Report: TAB Report
Function: Test, Adjust, & Balance
Date: 09/05/2025
Completed By: National TAB

PROJECT
08-25-25 WAWA #6613 CHANTILLY, VA

Issue List

Issue Name : EF1 & 2 LOW

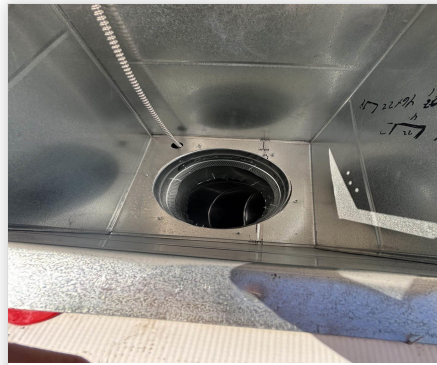
Description : Both speed controller dials are max speed, not enough total exhaust from either EF

Issue Name : EF1-2 DIFFUSER

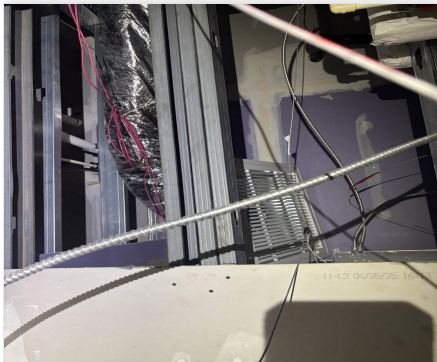
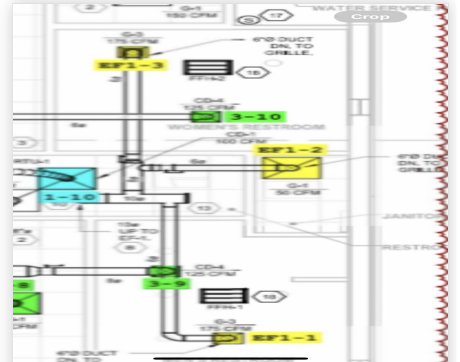
Description : Ef1-2 diffuser is sitting above the ceiling, not installed. Cannot reach to read cfm with Pitot tube Could very well be causing leakage of air

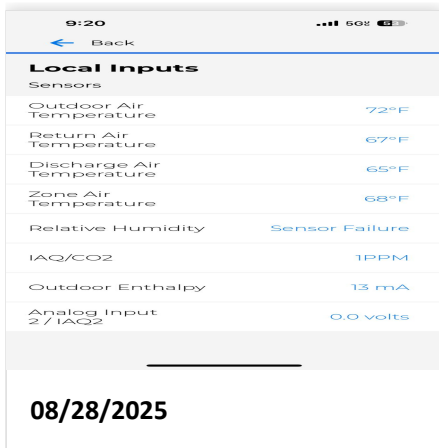
Issue Name : RTU DIFFUSERS
Description : Unable to reach ceiling diffusers, need some type of lift or taller ladder
Cannot hit diffuser dampers
Created By : National TAB **Assigned To :** National TAB - Cody Mauro
Status : Open
Priority : High **Asset Tag :**
Originated Date : 08/25/2025 - Cody Mauro - National TAB

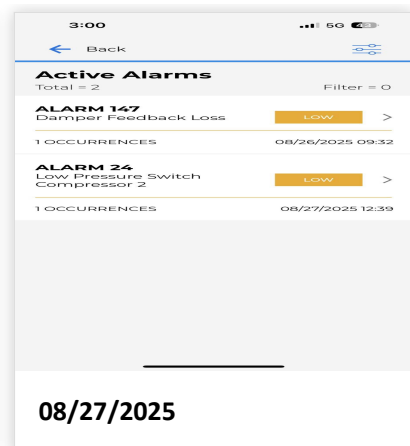
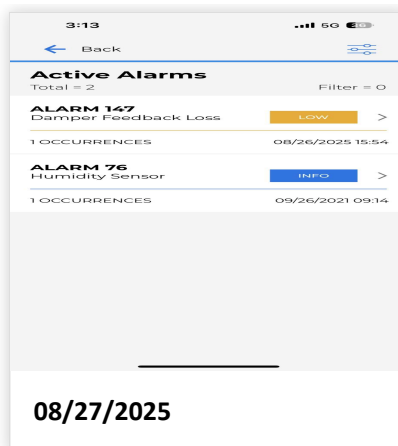
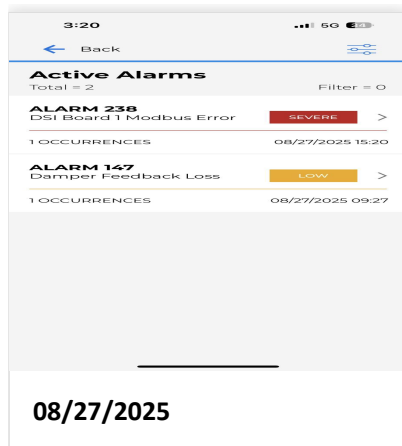
Cannot open panel without insulation getting sucked off. Needs to be resealed

Verify that the CORE or Prodigy controller is sensing a relative humidity (record the reading) Fail

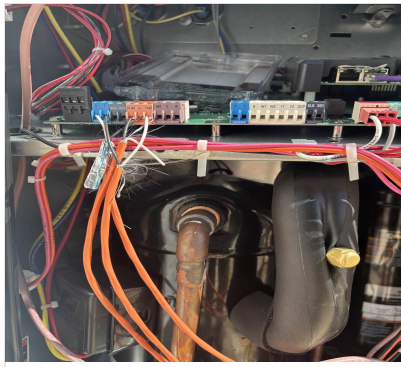
RTU1: 62% RTU2: Sensor Failure RTU3: 55%

Total exhaust flow balanced within +/-5% and grilles are within +/-10%?

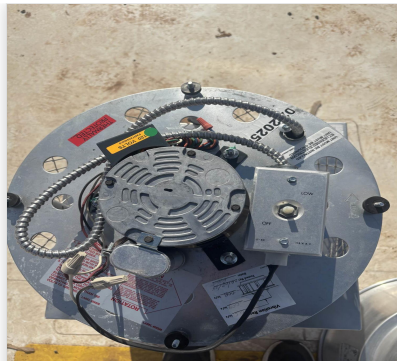
Speed controllers for both EF's are maxed, total not within +/-5%. Grilles unable to be balanced due to lack of air.
